TM-1461 (SSC-N-350) 1100.700

Checking the Numbers for the Labyrinths Shown in the SSC Conceptual Design*

J.D. Cossairt Fermi National Accelerator Laboratory P.O. Box 500, Batavia, Illinois 60510

April 1987

Figure 6.6-4. Collider Ring Access Shaft plan view

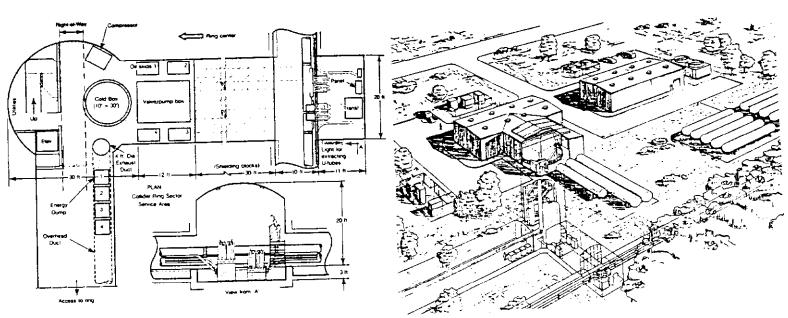
First consider the ring access shaft. I could not find this structure shown in its entirety in the report so I have had to guess what it might look like based upon the written description. The following sketch is an expression of my interpretation. It is to be noted that the length of the second "leg" has not been specified so I will end this discussion by making a suggestion.

The **first leg** has a cross sectional area of about $5.4 \times 5.4 \text{ m}^2$. Its length, according to my interpretation of the figures, is 17.3 m so that it is 3.2 "units" long. Consider the source to be a "line source", Figure 6 of (Go71) gives an attenuation factor of **0.25** for this leg.

Sections after the innermost were found by Gollon and Awschalom to be similarly effective for rectilinear labyrinths. Since the length of the second is presently unspecified, consider the **third section**. This leg, the vertical shaft, has a cross sectional area of $65~\text{m}^2$ if one ignores any concrete structures which might be installed (likely to be thin and of limited shielding effectiveness). This means that a "unit" = 8 m. The length of this section, taking the shield over the ring to be the minimal 7 m, is only about 1.2 "units". Still, going around corners always helps and this leg, by the figure from (Go71) attenuates by a factor of **0.06**.

The **second leg** must provide the remaining attenuation factor of 6.6×10^{-5} . From the figure, this will occur after 10 "units", or 54 m. These passageways can be made considerably shorter by making them smaller in cross section according to the scaling rules of Gollon.

Figure 6.7-1. Plan View of Type A Interaction Region showing collision hall, access way, shield doors, assembly area and Staging Building.

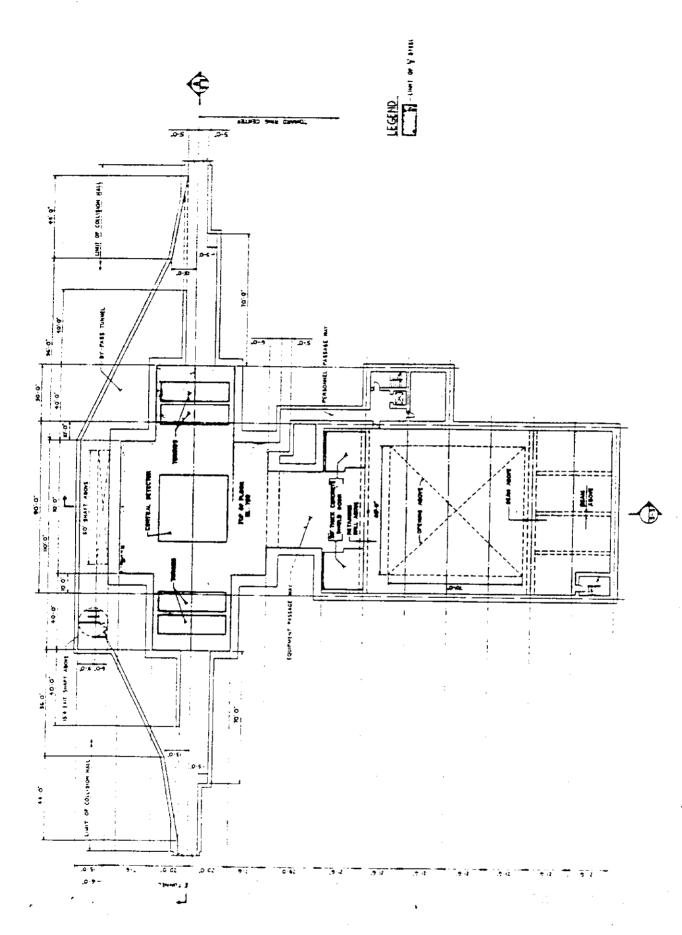
For a "Type A" Interaction Regions (both types being nearly the same for purposes of this discussion) the same procedure may be used. It should be noted that the "mouth" is 37.5' (11.4 m) from the nearest point to the beamline and 48' (14.6 m) from the intended vertex of the collisions. Having no better information, I have estimated that the cross-sectional dimensions of these passageways (which appear to be designed purely for people) to be 5' X 8' which implies a cross sectional area of 40 ft². Thus $(A)^{1/2} = 6.3$ ft (1.9 m). Thus the **first leg** is about 1.4 "units" long. From Fig. 6 of Gollon's work, it is conservative to take the attenuation factor of this section to be **0.45**. Continuing with the **second leg**, it is about 17 ft (5.2 m) long and hence approximately 2.7 "units". Thus the figure gives an approximate attenuation factor of **8 X 10^{-3}** for the second leg. Going now to the **third leg** we find it to be 42 ft (12.8 m) and hence 6.7 "units". The

resulting attenuation factor may be read off as 4×10^{-4} . Thus the total attenuation for the three-legged labyrinth is 1.4×10^{-6} .

at the mouth of the labyrinth. Multiplying by the attenuation factor determined above would result in a dose equivalent of **3.8 mrem**. It is clearly unlikely that the interaction regions would ever be truly empty, or just contain a bare beam pipe. However, it is more likely that massive components would be in place which would reduce this dose by self-shielding. At any rate, such a catastrophic beam loss is unlikely to occurr even as frequently as annually. This dose equivalent is therefore acceptable for such a controlled laboratory area.

The other type of loss is the steady loss due to the inelastic collisions of the 20 TeV protons. From Figure 144 of the work of Van Ginneken cited above, one finds a dose of 5 X 10^{-9} mrem/inelastic collision at a radius of 10 m from the vertex. This estimate is <u>highly</u> conservative due to the forward propagation of the particles from these collisions. Nevertheless, allowing for vertex to be in the <u>wrong</u> location (a highly surprising event to the accelerator physicists!) this is a somewhat useful <u>maximum</u> value. If we have, at $\mathbf{L} = 10^{33}$, 9 X 10^{7} collisions \mathbf{s}^{-1} or 3 X 10^{11} h⁻¹, one would have a maximum dose rate at 10 meters of 1500 mrem h⁻¹. Multiplying by the attenuation calculated above results in a dose equivalent rate of **2.1 µrem h⁻¹** at the worst point. This is an entirely acceptable value.

Thus it appears that the design of the access penetrations is appropriate
